NL-09-056

SUBJECT: Entergy Nuclear Operations Inc.
Indian Point Nuclear Generating Unit Nos. 2 & 3
Docket Nos. 50-247 and 50-286
**Reply to Request for Additional Information (RAI) –
Open Items Items**

**INDIAN POINT NUCLEAR GENERATING UNIT NOS. 2 AND 3
LICENSE RENEWAL APPLICATION AMENDMENT
REQUEST FOR ADDITIONAL INFORMATION – OPEN ITEMS**

**INDIAN POINT NUCLEAR GENERATING UNIT NOS. 2 AND 3
LICENSE RENEWAL APPLICATION
REQUEST FOR ADDITIONAL INFORMATION (RAI)
CLARIFICATION**

FIGURE 1

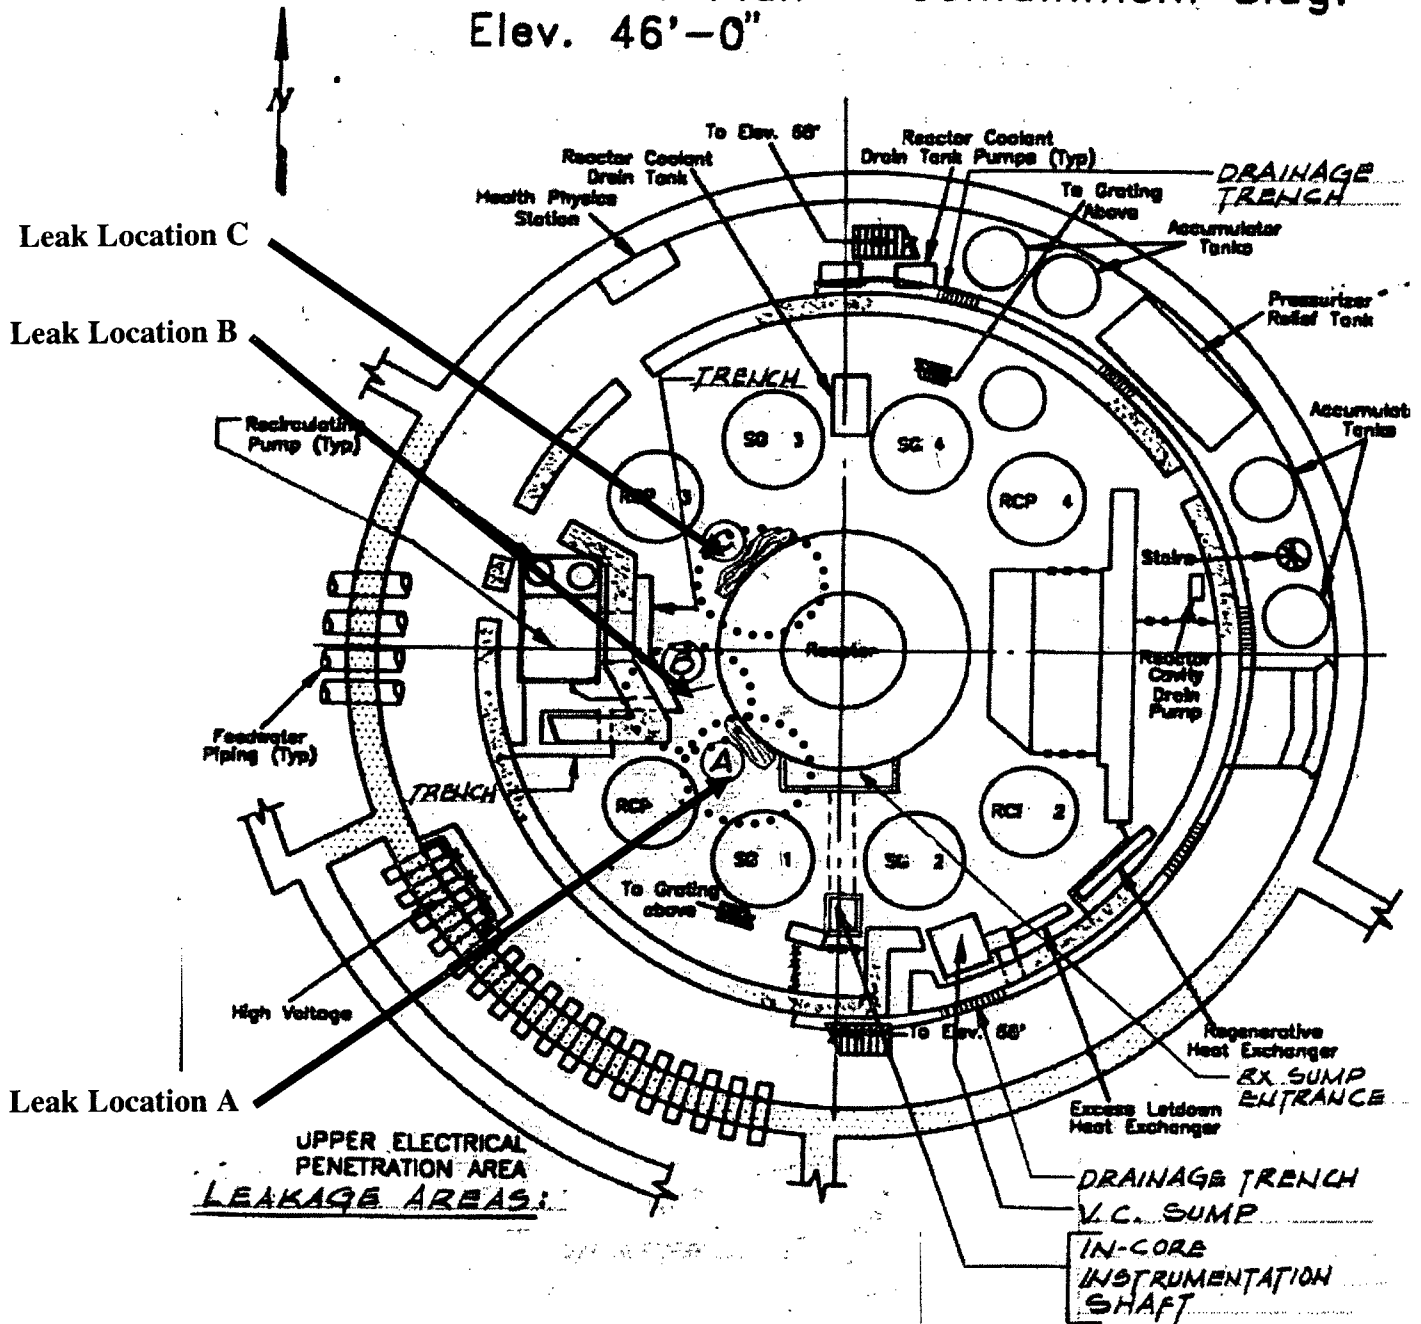
a. In order for the staff to address the adequacy of the applicant's proposed monitoring method, the applicant is requested to provide additional information on the leakage path from the refueling cavity to the collection point lower in containment, as well as the leak flow-rate. In this regard, describe the leakage path and chemical composition of the leaking fluid, provide historical flow-rate values, and confirm whether or not any leakage enters the reactor cavity inside the primary shield wall. Provide the technical basis as to how the leakage path was determined, with a focus on water entering the reactor cavity. Provide a sketch of containment and the refueling cavity which highlights the leakage path.

The suspect leakage path was determined by visual observation during and after filling the refueling cavity with water. Leakage is observed as the cavity is filled for refueling operations. Leakage starts as the cavity level reaches the 80 ft. elevation which is approximately 50% cavity level. Leakage was observed initially from three significant areas associated with refueling cavity construction (See Figure 1). Leakage from the refueling cavity collects in a drainage trench on the 46 ft elevation of containment inside the crane wall from where it flows to the containment sump.

The leaking fluid from the refueling cavity is mixed reactor coolant and refueling water storage tank water with total estimated flow rates on the order of 3 to 7 gpm. No samples of the fluid flowing from the leaking areas have been analyzed for chemical composition. There has been no degradation of containment structural surfaces from this wetting as observed in the Structures Monitoring Program. Figures 1 through 4 are sketches of the containment area and the refueling cavity which show the locations of the observed leakage.

FIGURE 5

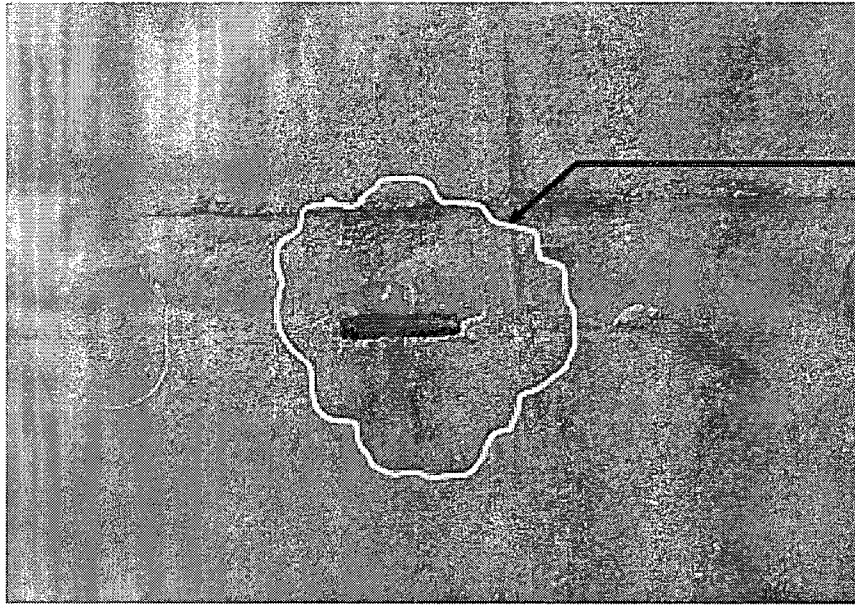
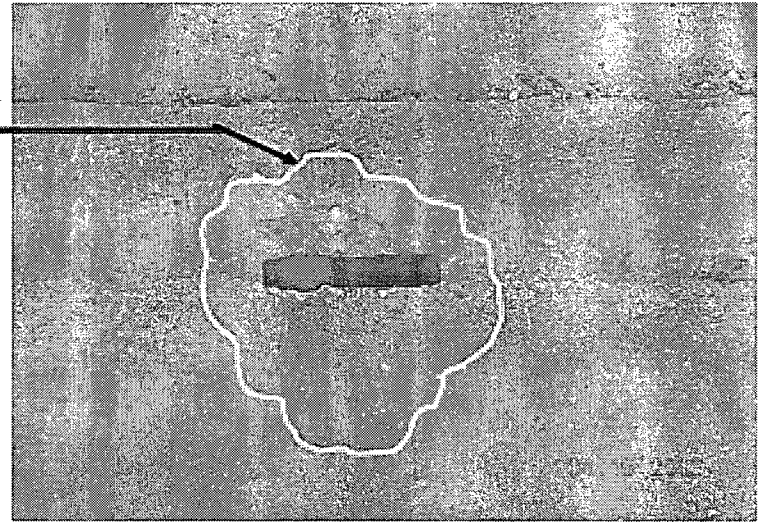
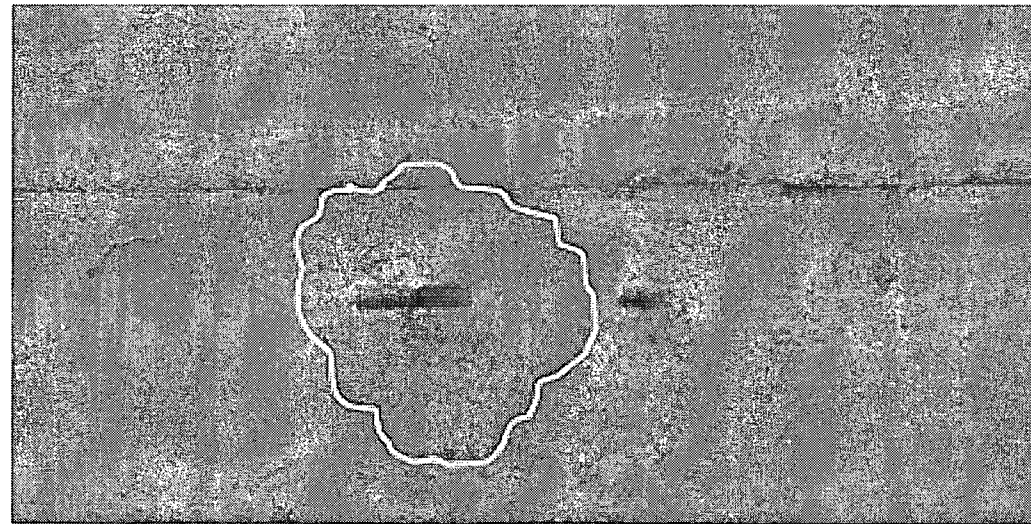
b. In the spent fuel pool discussion, in the letter dated November 6, 2008, the applicant stated: “[l]ittle or no corrosion was observed in the rebar except at a location in the wall where spalling had occurred exposing rebar to the elements. Analysis of the rust particles showed high chloride content and low boron concentration indicating that rainwater was the primary cause of the observed corrosion.” The applicant is requested to provide the technical basis for the adequacy of the 5-year IWL frequency of inspection of the degraded areas of the IP containments during the period of extended operation, considering the possibility of an increased site-specific corrosion rate of the exposed rebar on the containments. This should include results of prior inspections, including any available comparative photos showing the progression of degradation.

The technical adequacy of the 5-year IWL frequency of inspection of the degraded areas of the IPEC containments has been demonstrated by past inspection results. No detectable changes have occurred over the 5-year period between past inspections. The rate of degradation of the exposed rebar of the containments has been imperceptible. Documented inspection history for the first period IWL inspection began in 1999. Photographs taken of exposed rebar in the most recent inspection in 2009 were compared to photographs taken during the first IWL interval inspection in 2000 and a subsequent inspection in 2005. As can be seen from the photos in Figures 5 through 7 corrosion of the exposed rebar is almost nonexistent with no noticeable change in appearance over the years. Spalling is confined to a small area around the rebar with no noticeable cracking being present, which would indicate that the degradation is localized or has not progressed along the length of the rebar creating the potential for more spalling. Therefore, based upon past and recent inspection, increased corrosion rates have not been identified and additional degradation, which could prevent the containment from performing its intended function, would be readily detected by the established IWL inspections.

2" high by approx. 8" long Crack
On Cylinder portion of U2
CONFIDENTIAL

FIGURE 8

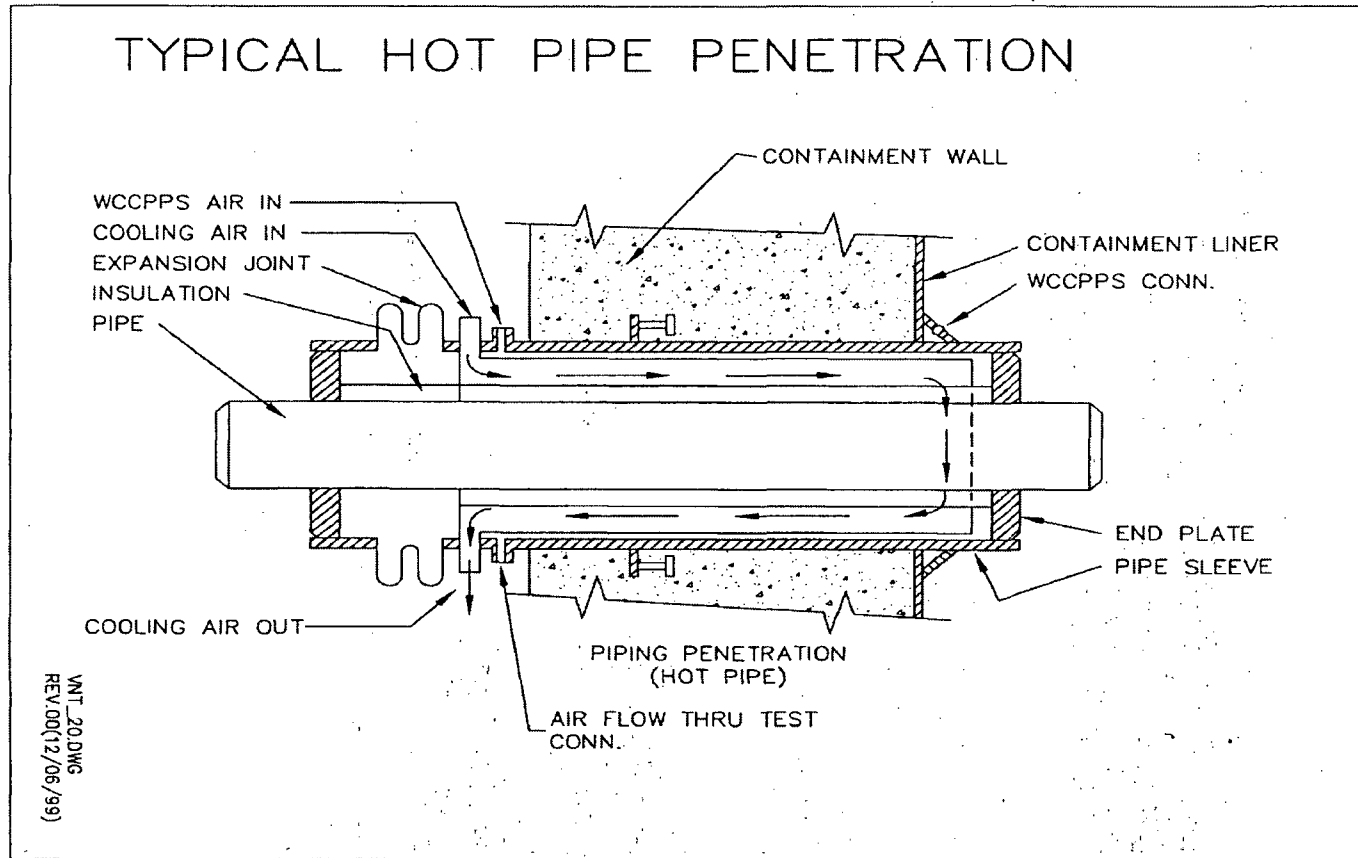
a. Clearly explain the role of the air-to-air heat exchangers in cooling the concrete around the hot piping penetrations. Include the normal operating temperature of the concrete as well as the maximum concrete temperature assuming failure of the heat exchangers.

The HPC system comprises two separate and non-interconnected subsystems. Each subsystem is composed of 2 positive displacement blowers, valves, air-to-air heat exchangers and connecting piping. Each of the subsystems blowers supplies air from outside the building to the air-to-air heat exchanger which cools the space between the process line insulation and the penetration sleeve. The air-to-air heat exchanger is made by welding together one flat sheet on one embossed sheet of 10-gauge carbon steel. The embossment forms the coolant channels, through which the HPC system air passes. The unit is rolled into the form of a cylinder with an outside diameter of the penetration sleeve and inside diameter that allows placement over the outside of the pipe insulation (See Figures 8 and 9). A typical hot penetration detail is shown in IP2 and 3 UFSAR Fig 5.1-30 and 5.1-12 respectively.

There is one subsystem with two blowers for the main steam and feedwater penetrations, and one subsystem with two blowers for the hot penetrations in the radiological controlled area. Only one blower is needed in each subsystem. In the event that the operating blower stops, an alarm is initiated signaling to put the other one in service and initiate corrective actions:
